Item ID: D350-607-041 Accept ***N900040100*** Setup Start ***NS1***
Revision ID: Stop ***NS2***
Item Name: AS350/AS355 Heli-Utility-Basket™ Long Version - Fits LH or RH
Start Date: 5/30/2016 Start Qty: 1.00 ***1*** Cust Item ID:
Required Date: 6/6/2016 Req'd Qty: 1.00 ***1*** Customer:
Reference:

DART SERVICE INSTRUCTION
TO AMEND INSTALLATION INSTRUCTIONS D350-607-1 REV. A AND
INSTRUCTIONS FOR CONTINUED AIRWORTHINESS ICA-D350-607 REV. 6
REF CANADIAN STC: SH94-14
REF FAA STC: SR00213NY
REF EASA STC: 10016996

A	NEW ISSUE	MB	14.09.25
REV.	DESCRIPTION	BY	DATE
DESIGN		DART AEROSPACE LTD HAWKESBURY, ONTARIO, CANADA	
DRAWN			
CHECKED		DRAWING NO.	REV. A
MFG. APPR.	N/A	DSI 9709	SHEET 1 OF 4
APPROVED		TITLE	SCALE
DE APPR.		PARTS LIST CORRECTION	NTS
DATE	14.09.25	COPYRIGHT © 2014 BY DART AEROSPACE LTD THIS DOCUMENT IS PRIVATE AND CONFIDENTIAL AND IS SUPPLIED ON THE EXPRESS CONDITION THAT IT IS NOT TO BE USED FOR ANY PURPOSE OR COPIED OR COMMUNICATED TO ANY OTHER PERSON WITHOUT WRITTEN PERMISSION FROM DART AEROSPACE LTD.

**FIGURE 1: CHANGES TO FIGURE 2 OF D350-607-1 REV. A
AND FIGURE 25-1 OF ICA-D350-607 REV. 6**

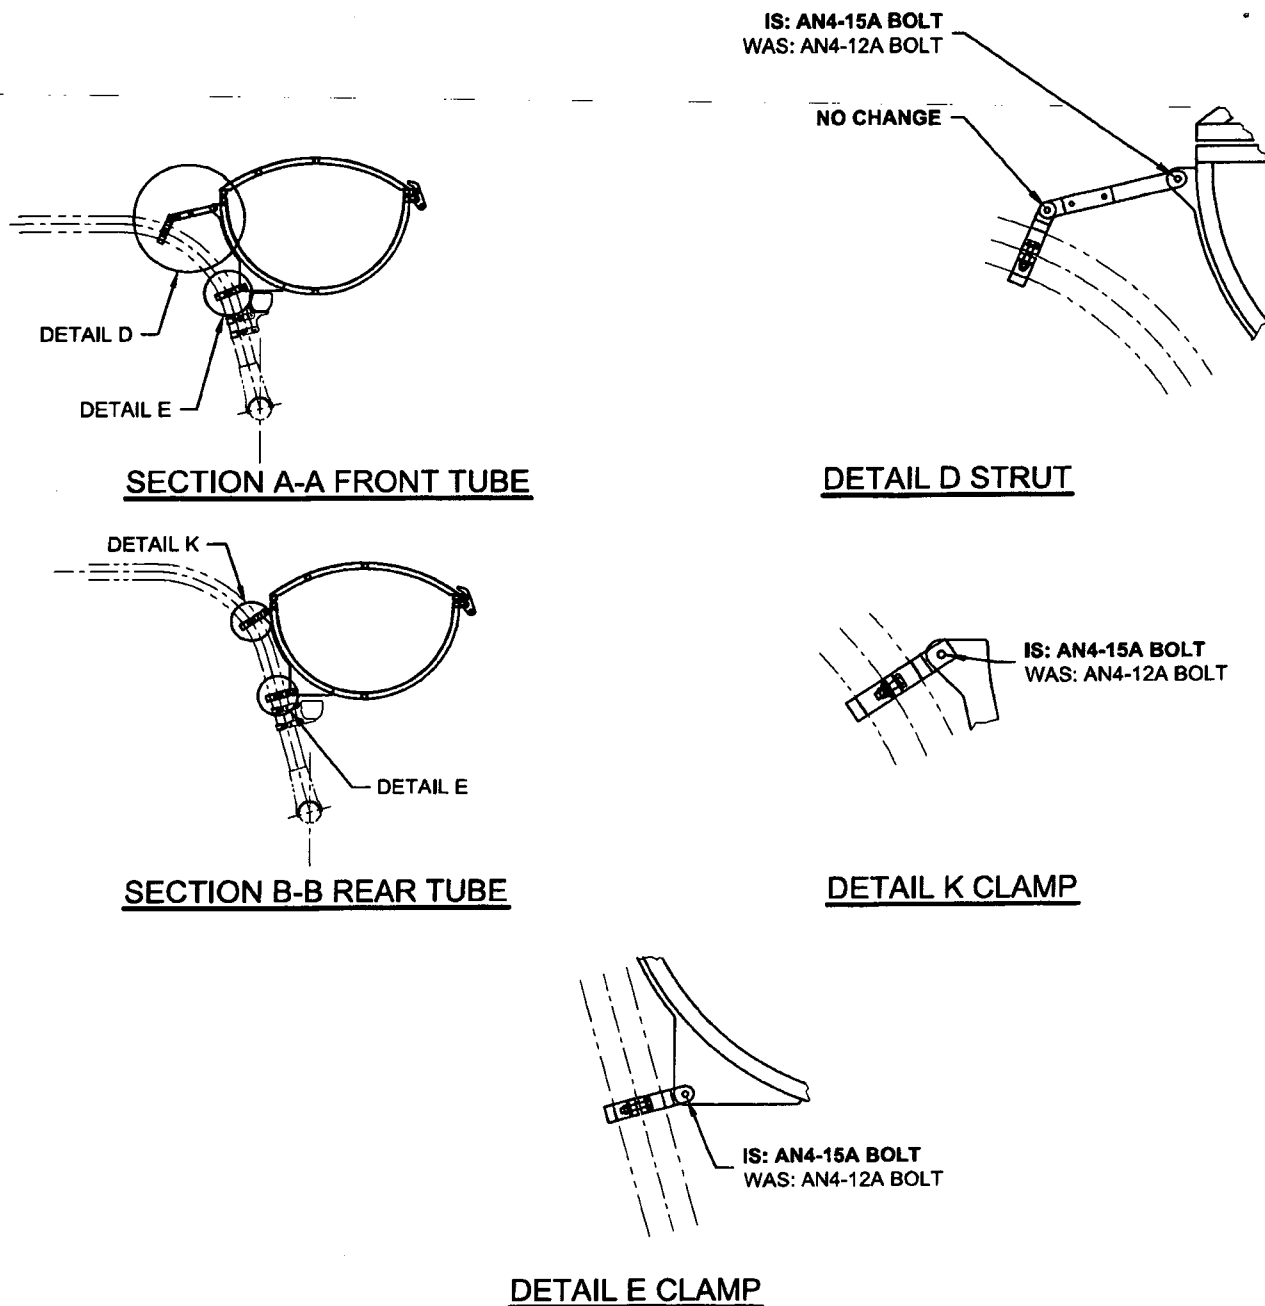
It has come to DART's attention that Installation Instructions D350-607-1 Rev. A and Instructions for Continued Airworthiness ICA-D350-607 Rev.6 were issued with incorrect bolt length information. The purpose of this DART Service Instruction (DSI) is to amend the following items:

- 2.1 Sheet 2 of this DSI amends Figures 2 of D350-607-1 Rev. A and 25-1 of ICA-D350-607 Rev. 6;
- 2.2 Sheet 3 of this DSI amends Figures 3 of D350-607-1 Rev. A and 25-2 of ICA-D350-607 Rev. 6;
- 2.3 Sheet 4 of this DSI amends the Parts Lists of Installation Instructions D350-607-1 Rev. A (Sections 6.1 and 6.2) and ICA-D350-607 Rev. 6 (Sections 25.27.1 and 25.27.2).

**FIGURE 2: CHANGES TO FIGURE 3 OF D350-607-1 REV. A
AND FIGURE 25-2 OF ICA-D350-607 REV. 6**

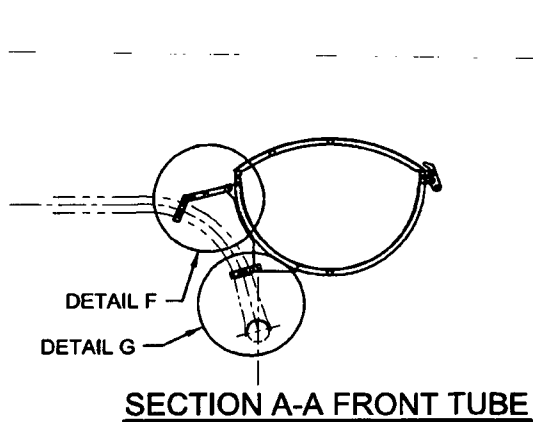
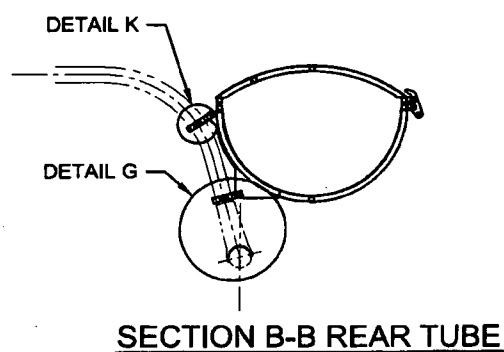
IS: AN4-15A BOLT
WAS: AN4-12A BOLT

DETAIL F STRUT
